Water Leak From Rear Sliding Roof Assembly

Service Category Vehicle Exterior

Section Sliding Roof/Convertible

YEAR(S)	MODEL(S)	ADDITIONAL INFORMATION
2011	Sienna

Figure 1.

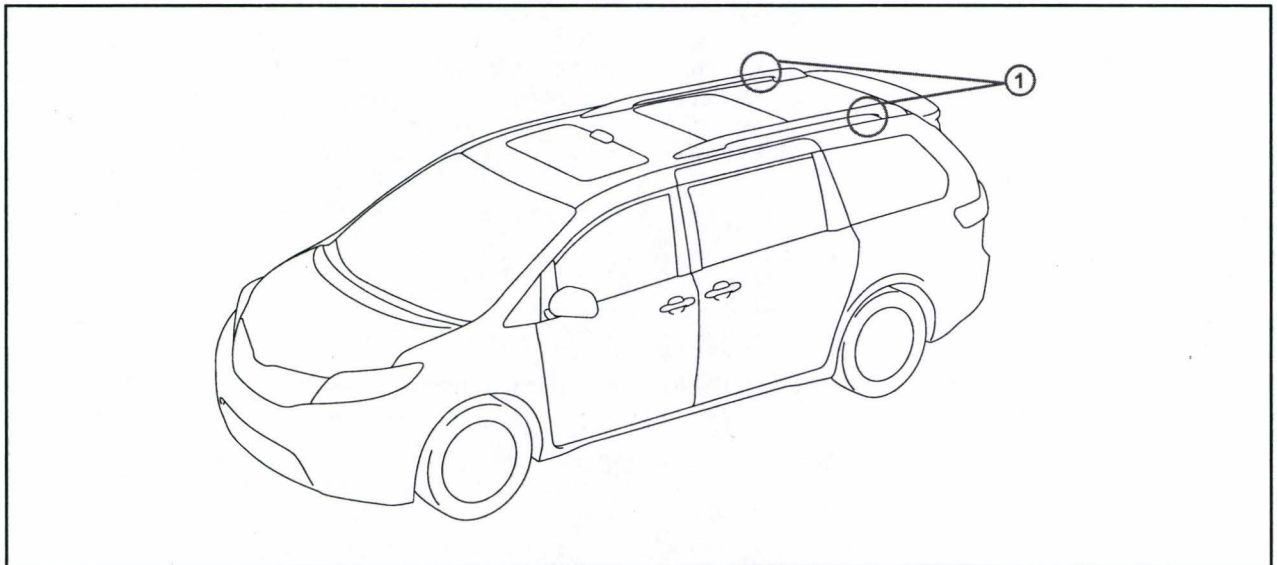
Some 2011 model year Sienna vehicles may exhibit a condition where a leak is noticed at the rear corner drains of the rear sliding roof assembly. This may be due to an insufficient amount of butyl sealer in the drain end caps. A new rear sliding roof housing sub-assembly has been developed to address this condition.

1	Leak Locations at Rear Corners of Sliding Roof
---	--

2. If leak is present, replace the rear sliding roof housing sub-assembly.
